**PLANNED UNIT DEVELOPMENT &  
SUBDIVISION STAFF REPORT**

**Date: July 15, 2004**

**DEVELOPMENT NAME** Rochester Place Subdivision

**SUBDIVISION NAME** Rochester Place Subdivision, Revised Plat of

# SITE PLAN

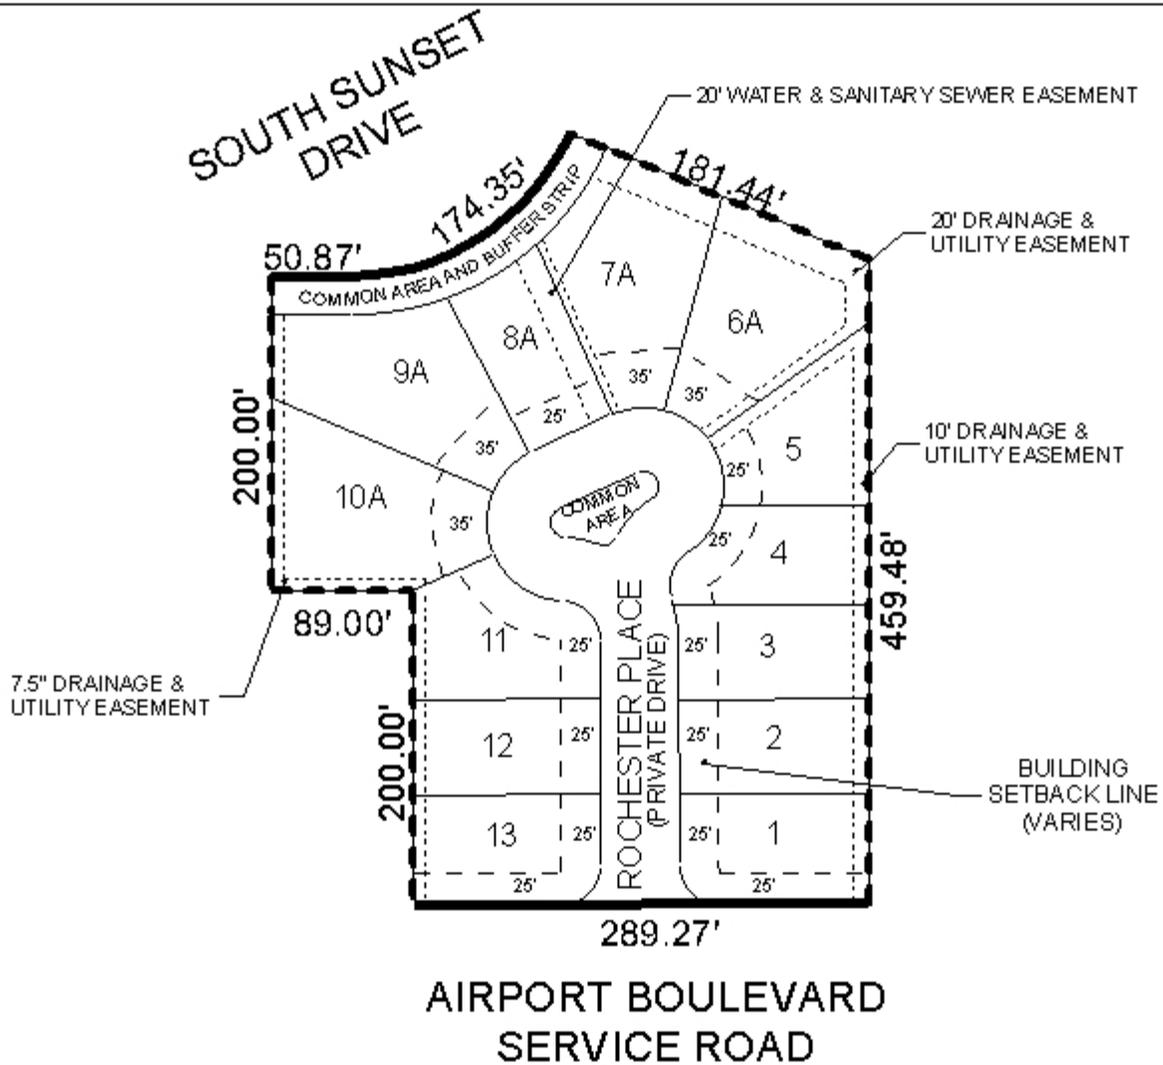
The plat illustrates the proposed conversion of a 13-lot, 3.4± acre subdivision to a private street subdivision. The applicant revised the approved subdivision to allow the vacation of the public street to create a 13-lot private drive subdivision.

The proposed development is not a family division of five or fewer lots, and the applicant has submitted no documentation that would justify consideration as an innovative subdivision, a gated community or that unusual difficulties exist.

There are no changes in the application, nor changes in any conditions surrounding the development or in the immediate vicinity, the staff comments from the previous application are also unchanged. Therefore, the proposed subdivision does not meet the criteria for a private road subdivision; moreover, the conditions of the previous subdivision, including the dedication and construction of the street to city standards, have been met and several homes have been constructed.

**RECOMMENDATION**      **Planned Unit Development:**      Based on the preceding, it is recommended that this application be denied.

**Subdivision:**      Based on the preceding, it is recommended that the application be denied.
